# GENERAL APPLICATION

Explanation of Request: DESIGN AND SITE PLAN APPROVAL FOR A MIXED USE DEVELOPMENT INCLUDING 2,357 SF OF COMMERCIAL AND 36 RESIDENTIAL UNITS

## PRELIMINARY TAC RESPONSE TO COMMENTS

SUBMITTAL: CITY OF HOLLYWOOD TECHNICAL ADVISORY COMMITTEE  
DATE: Monday, March 3, 2025

COVER SHEET AND GENERAL NOTES

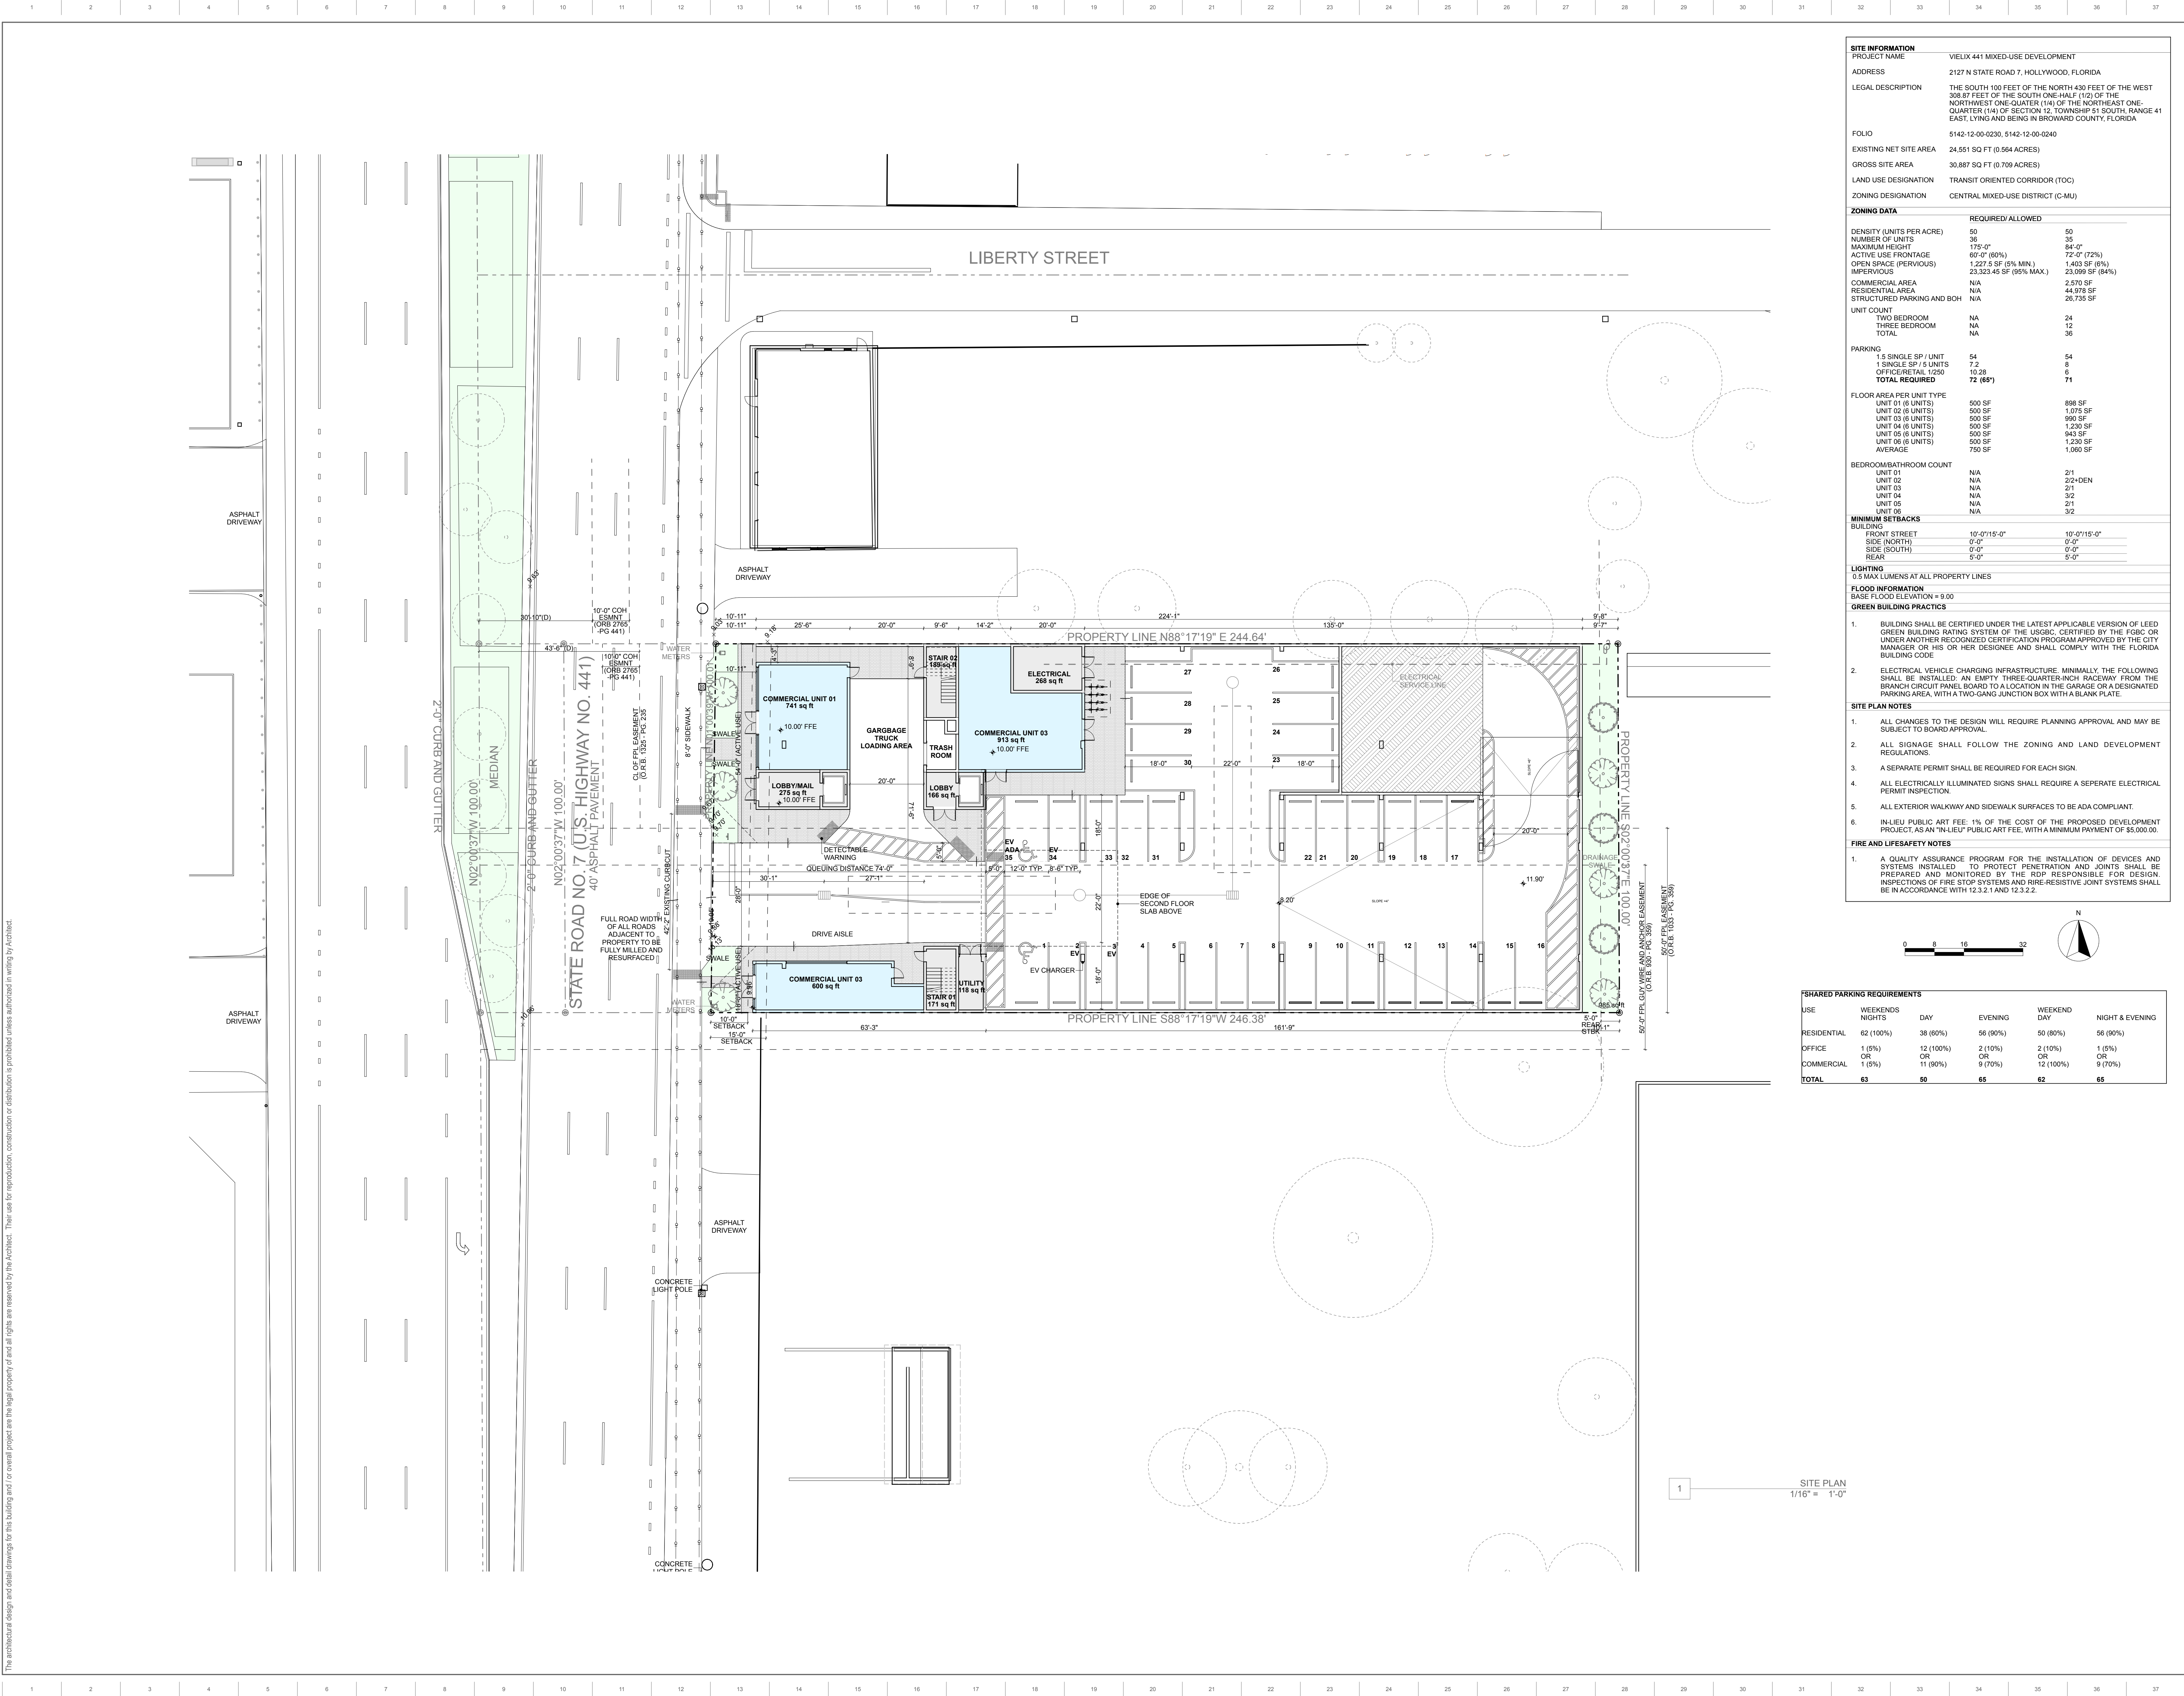
2 - The construction type on plan page A000 states "Type V-B" which I believe is incorrect. --- Clarify and correct on the plans.

**RESPONSE: Corrected on the Plans to IIA.**

CONTEXTUAL SITE PLAN

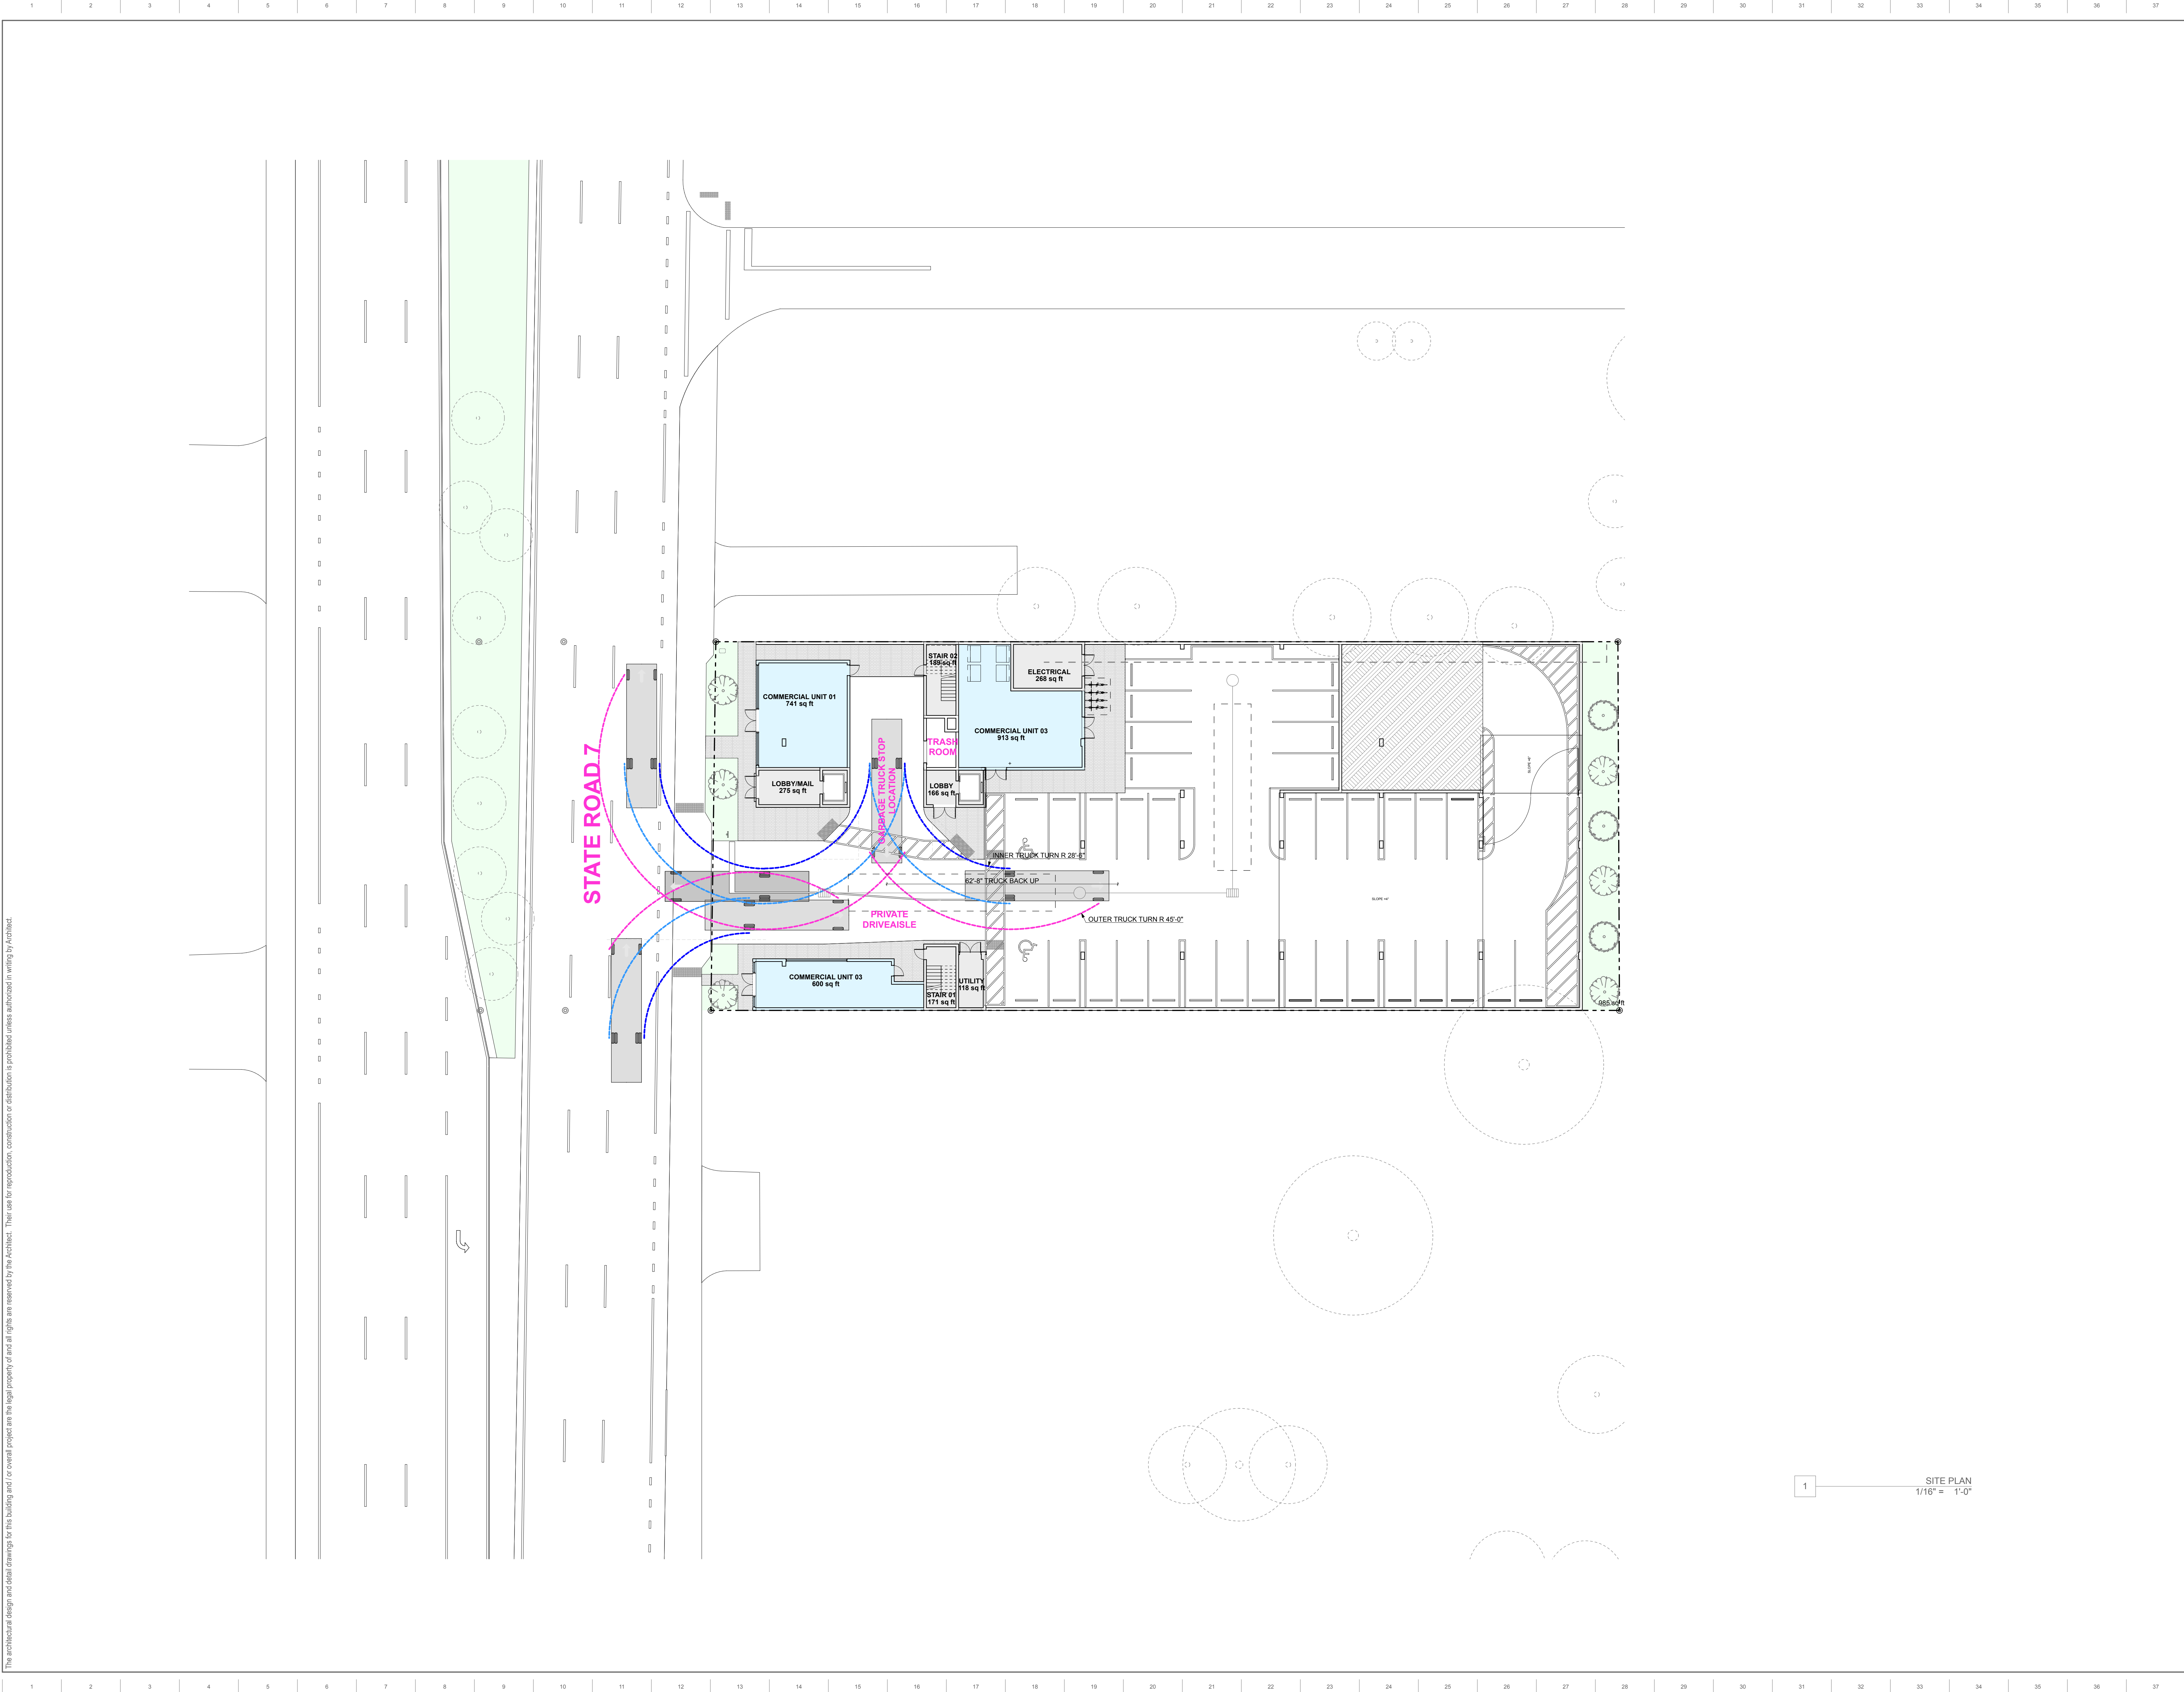
21) Please remove all overlapping text on Sheet A001. The property line may be identified via callouts with leaders.

27) There are detectable warning mats shown on A001. However, the limits and symbols are not clear. Please revise the plans as necessary.

**RESPONSE: Overlapping pert adjusted. Additional information indicated on sheets A005 and A006.**

**RESPONSE: Detectable warning shall expand the width of the crosswalk or sidewalk as indicated on sheet A005.**
